71 Macquarie Street, East Circular Quay (Amatil) MP10_0237

Submission to the Department of Planning of Planning and Infrastructure
29 February 2012

29 February 2012

Appendix A
Public Domain Improvements Plan

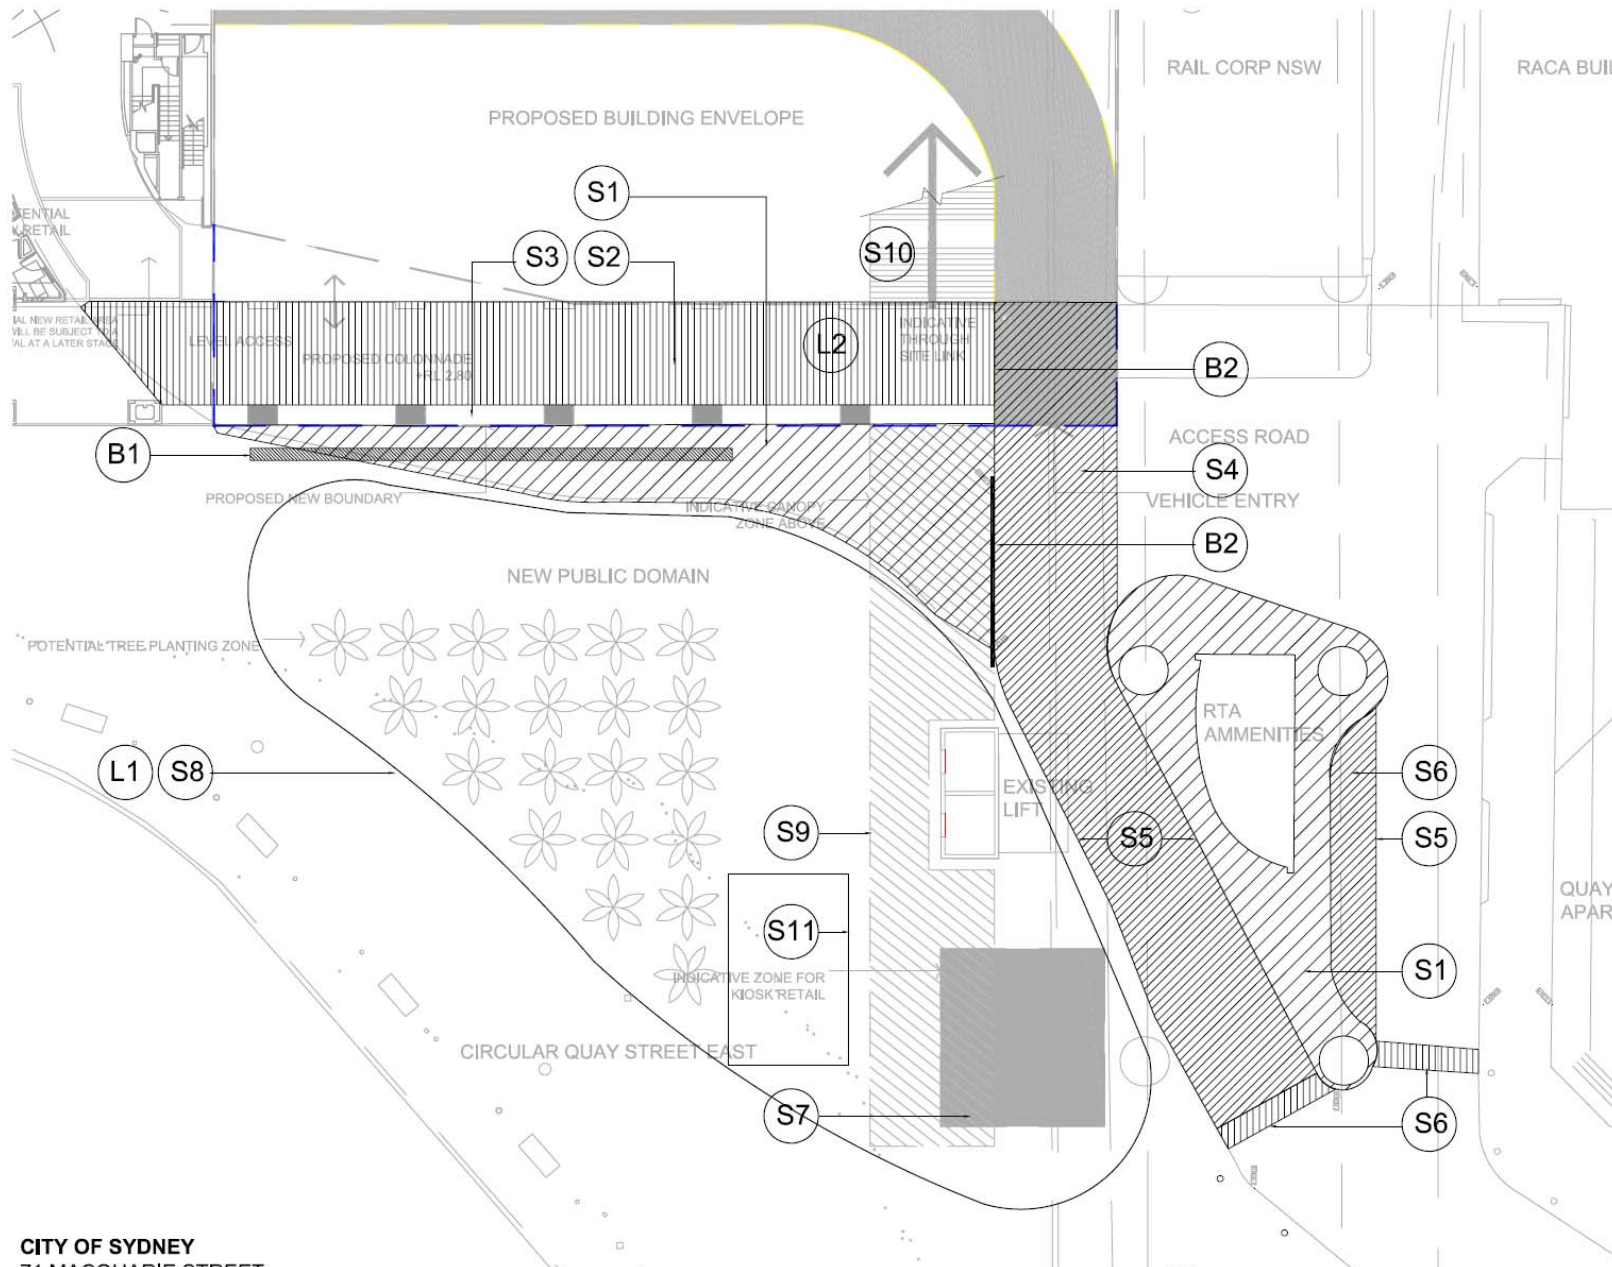
A preliminary set of anticipated public domain improvements are contained within **Attachment 1 - Public Domain Improvements Plan**. These should be referenced in any approval.

The City requires specific items as part of any future public domain works. These are outlined in **Attachment 1** and include replacement of disturbed existing pavement, upgraded pavement surfaces and kerbing to trafficable areas, new street furniture such as bins, benches and bollards, and signage replacements.

- KEY**
- Structures / Pavement**
- S1. Replace existing vehicular access with pedestrian pavement to match adjacent.
 - S2. Granite paving or tiling to Colonnade to match existing adjacent (Quay Grand).

- S3. Contrast granite paving to edge of colonnade - to match adjacent existing.
 - S4. Upgraded pavement to new vehicular access zone (shared surface treatment).

- S5. 200mm Trachyte kerb. Flush or raised as appropriate.
 - S6. New paving to car parking and ramps in existing locations.
 - S7. New cafe structure (existing to be demolished). Internal fitout to match standard of existing cafe.

- S8. New paving in place of demolished canopy structure, cafe and relocated palms.
 - S9. New canopy structure.
 - S10. New public stairway to Macquarie Street.

- S11. Possible outdoor dining area associated with future kiosk.
- Fixtures / Furniture**
- F1. Bollards - Allow for 6 new droppable bollards to shared surface near Alfred Street.

- F2. Lighting - replace or relocate existing lighting provision.
 - F3. Seating - allow 2 no. City of Sydney standard (City Centre).
 - F4. Signage - existing signage to be replaced.

- F5. Bins - allow 1 no. City of Sydney standard (City Centre).
- Special / Bespoke elements**
- B1. Linear water feature / Public Art element.
 - B2. New vertical screen structure to min. 6m height x 5m wide.

- Tree Planting**
- L1. Existing palms to be relocated into new layout, Relocation of existing, or installation of new, in ground uplights to palm trees.

- L2. Relocation of existing Pepper Tree.
- NOTES:**
1. Refer to City of Sydney Interim Sydney Streets Design Code for material/product specifications.
 2. Allow for regrading as necessary to make an even grade of surface in pedestrian areas.
